# TECHNICAL EVALUATION REPORT

## HYDROLOGICAL CONSIDERATIONS

ROCHESTER GAS & ELECTRIC CORPORATION

R. E. GINNA NUCLEAR POWER PLANT

Figure 6. Sectional View of Ginna Plant Site Showing Bedrock, Zone of Saturation, and Surface Section A-A'

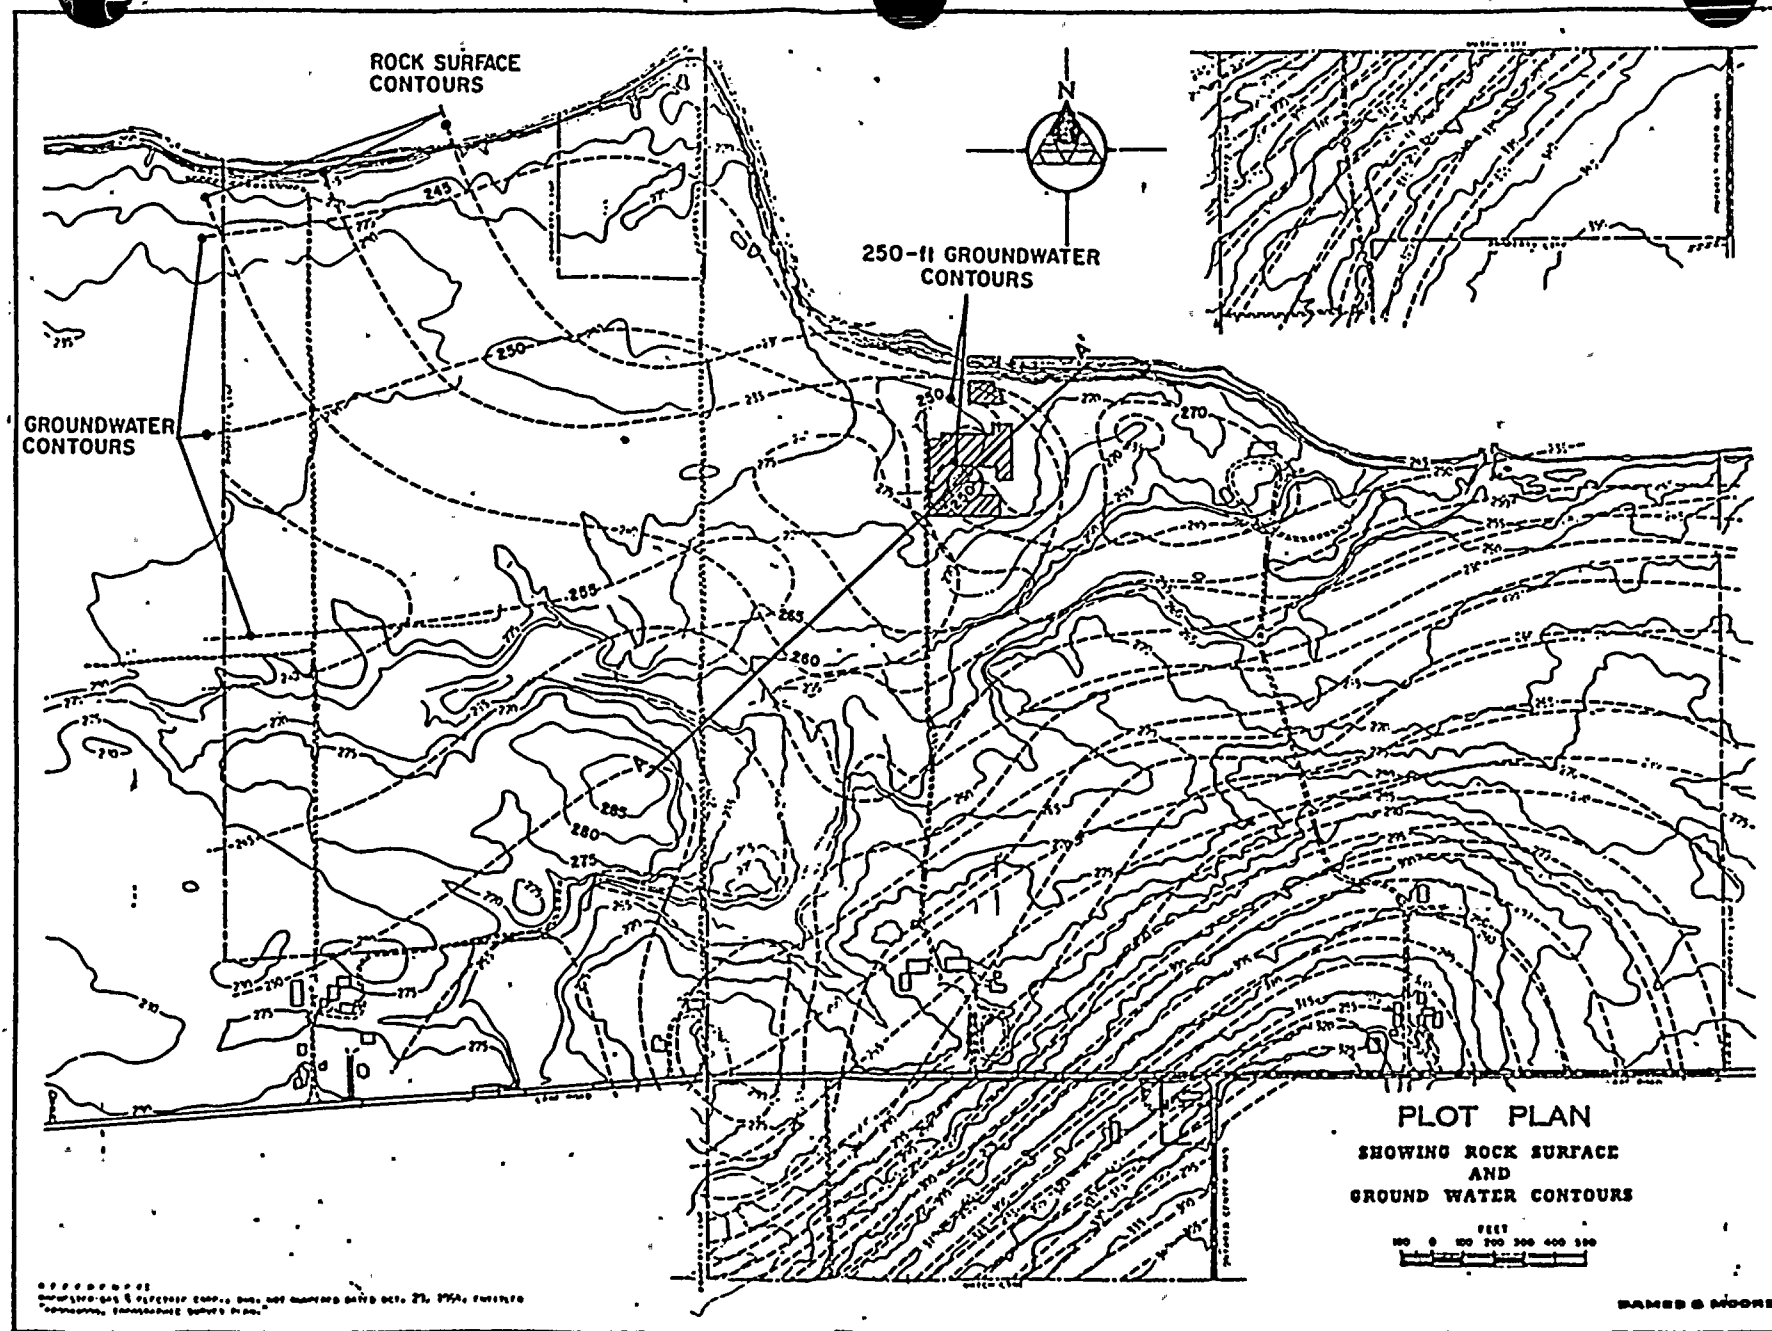
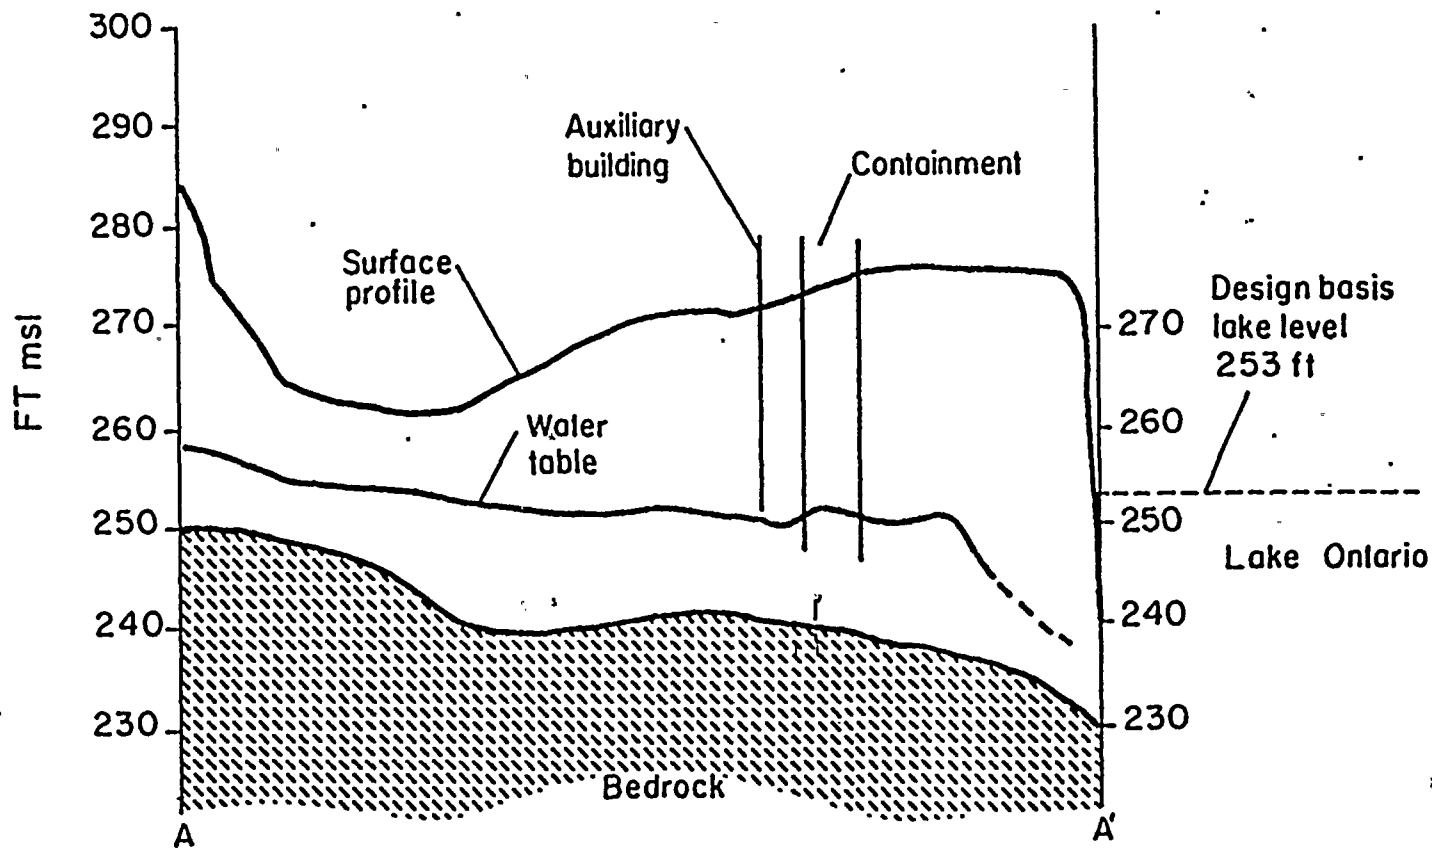
The original groundwater studies (and other site studies) were conducted for the Licensee by Dames & Moore in 1964-1965 [20]. A plot plan of rock surface and groundwater contours, dated October 29, 1964, shows the findings of the Dames & Moore site survey. The plot plan is reproduced here as Figure 5 and contains identification and differentiation of rock surfaces and groundwater contour elevations for contour lines near the plant.

A cross-sectional view, based on the Dames & Moore plot plan, along section A to A' depicts the relationship of bedrock, water table, and ground surface elevations (see Figure 6). Although it is true that the water table reaches 247 ft at the plant, it is also true that, according to the plot plan, the groundwater elevation is somewhat above 250 ft near the containment. No information is presently available to determine whether these groundwater elevations were the highest, average, or lowest elevations recorded during the site survey.

Although it is not clear when the groundwater data were collected for the Dames & Moore report [20], the previously identified meteorologic conditions suggest that groundwater elevations were likely to be lower than normal during the period from fall 1963 to spring 1965. Thus, groundwater elevations identified on the site survey plot plan by Dames & Moore are likely to be non-conservative design basis elevations. Therefore, it is recommended that ground elevation (270 ft msl) be used as a conservative design review elevation.

The design basis groundwater elevation at 250 ft msl is likely to be a non-conservative elevation based on a review of information provided by the Licensee. It is recommended that plant grade (elevation 270 ft msl) be used as the design review basis.

Figure 7. Site Plot Plan Showing Location of Borings, Seismic Lines, Test Pit, and Excavation

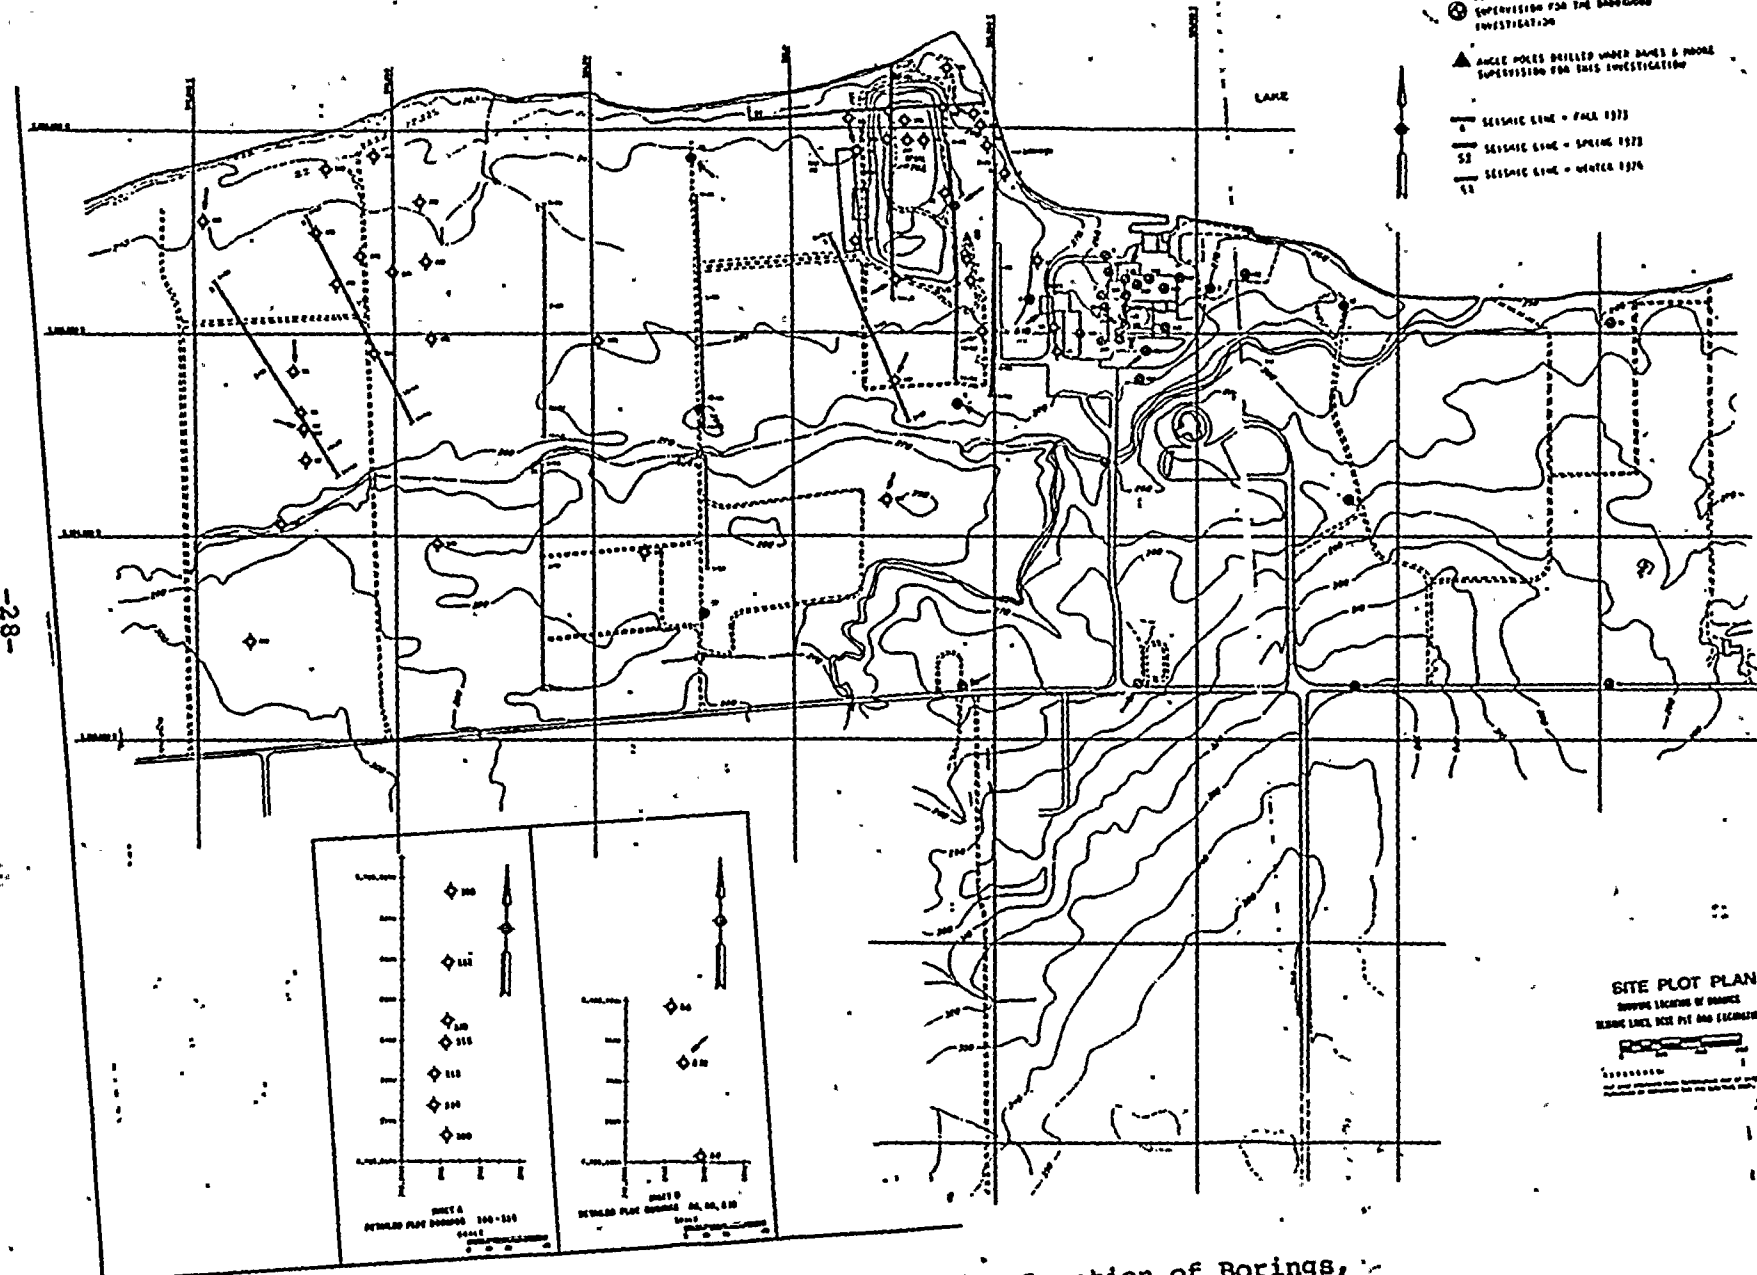
Figure 7 identifies the surface locations of 10 of these borings. Boring number A10 is approximately 500 ft west of the containment building, and boring number B2 is approximately 650 ft west of the containment building. Of the 10 borings identified in Table 3, these 2 borings are the closest to the Ginna plant.

These borings show that groundwater has exceeded elevation 250 ft msl, the design basis elevation, for locations near the Ginna plant. This information further demonstrates that the design basis groundwater elevation at the Ginna plant is likely to be non-conservative.
